Weil-McLain Product Bulletin
PB1703 - April 28, 2017

Modified Standard Sidewall Vent Termination Kit – Ultra Gas, WM97+ and GV90+ Boilers

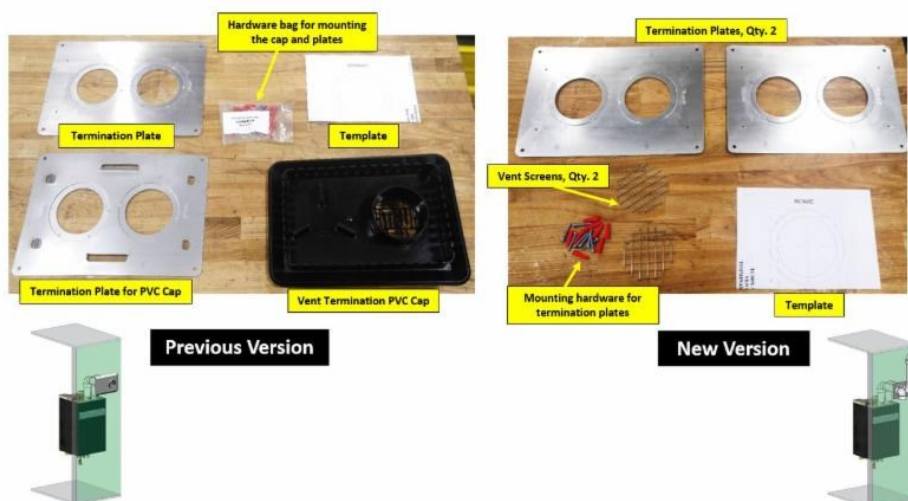
Our Ultra Gas, WM97+ and GV90+ gas boilers currently ship with a sidewall vent/air termination kit, as standard equipment. Last year we transitioned from including the black Vent Termination PVC Cap, to just the sidewall termination stainless steel plates and bird screens.

The differences between the previous and new kit versions are shown below.

The previous Sidewall Vent/Air Cap Termination Kit (which includes the black vent termination PVC cap) is still available and can be ordered as an optional kit from our Trade Price Schedule - part #383-500-397 3" kit for UG 80-155, WM97+ and GV90+ boilers; and part #383-500-398 4" kit for the UG 230-399 boilers.
